PRIVATE PLAN CHANGE 90
ADDENDUM HEARING REPORT
8 SPARKY ROAD, OTARA
HIGHBROOK LIVING LIMITED

Addendum to Hearing Report for Proposed Private Plan Change 90: (8 Sparky Road, Ōtara) to the Auckland Unitary Plan (Operative in part)

Report to:	Hearing Commissioners
Addendum Author:	Tania Richmond, Consultant Planner
Addendum Approver:	Marc Dendale – Team Leader, Planning Central South, Plans and Places
Hearing Dates:	25, 26 and 27 March 2024
Report produced:	23 February 2024

Figure 2.1: Proximity to Plan Change area

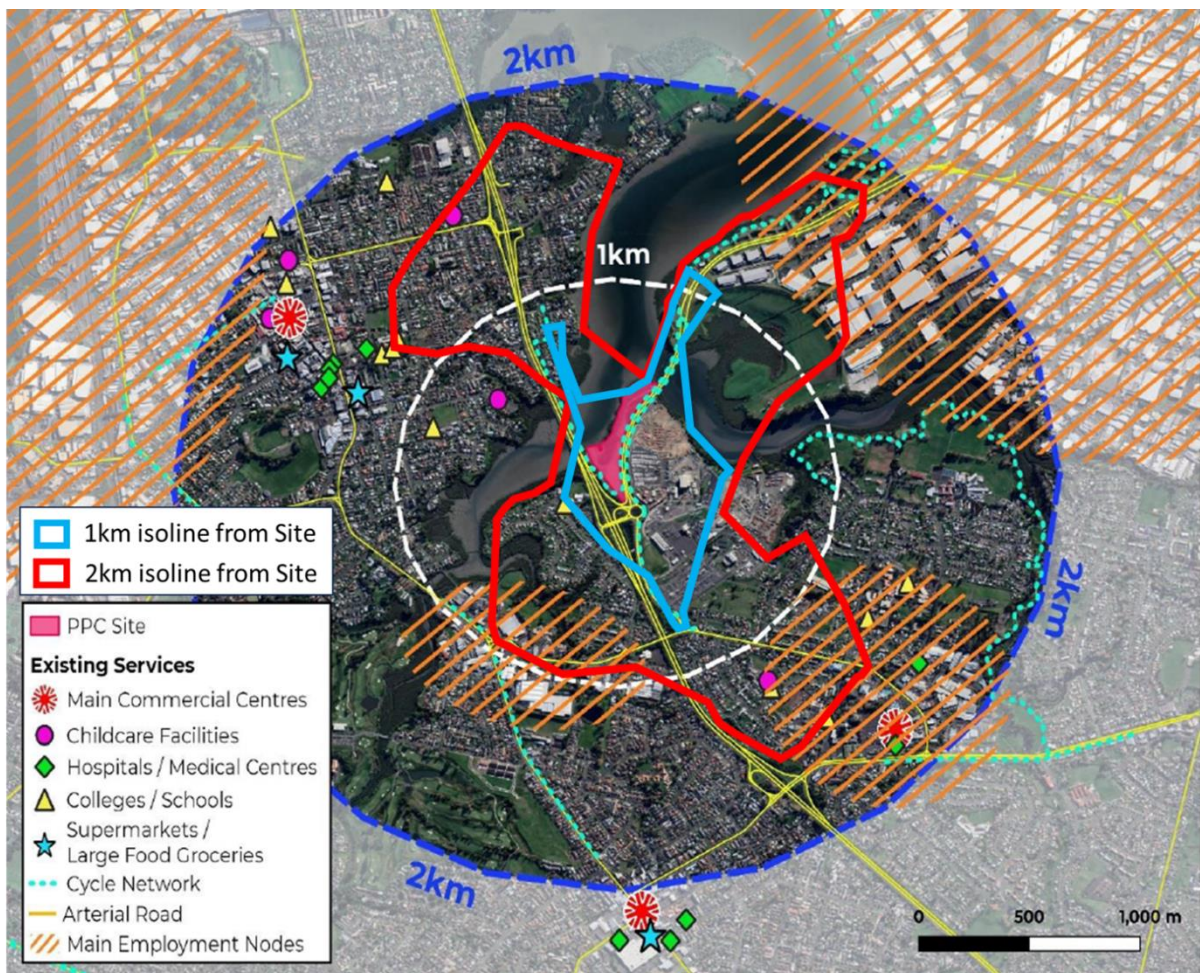
- 2.7 Further, Mr Heath's straight-line approach does not reflect true accessibility, which in practice is very much constrained by the presence of the Tāmaki River and Ōtara Creek, and the configuration of the roading/pedestrian path network in the area. Those things limit the places that can be reached on a 1km or 2km trip from the PPC area to an area much less than that which Mr Heath presents in his Figure 3. The limitation of using straight-line distances is recognised in the Council study Mr Heath refers to.⁴

- 2.8 To show the area actually accessible on 1km and 2km trips from the PPC area, I have used GIS to map 1km and 2km isolines (lines of equal distance from a starting point) from the PPC area. I have overlain those isolines on Mr Heath's Figure 3 (in my Figure 2.1 below), to show that contrary to Mr Heath's conclusions, and consistent with my contribution to the s42A report, there is very limited presence of commercial, community, or recreation facilities within 2km of the PPC area.

- 2.9 I note that in December 2022 the applicant provided a response to Council's Request for Further Information, which included as Attachment 2 a Walking Isochrone, which shows very similar patterns to my Figure 2.1, albeit based on walking time rather than distance. Mr Evans' evidence is consistent with my assessment and that Attachment 2.
